SPARE PARTS

DRIVE BELT KIT

Processed Cheese Slices
Wrapping Machine

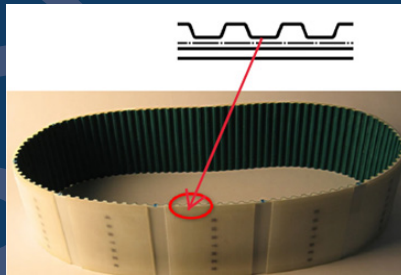
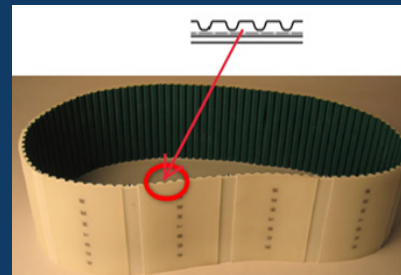
In order to improve the lifetime of your forming central belts and to reduce your maintenance costs, our engineers redesigned the central forming belt with new throat teeth and splitted the pulleys in three elements.

The combination of these two new elements improves the lifetime of the belts as the friction coefficient is reduced. Thus, they are now better adapted to high-speed machines.

3 PULLEYS AND 1 SET OF FORMING BELTS ASSEMBLY
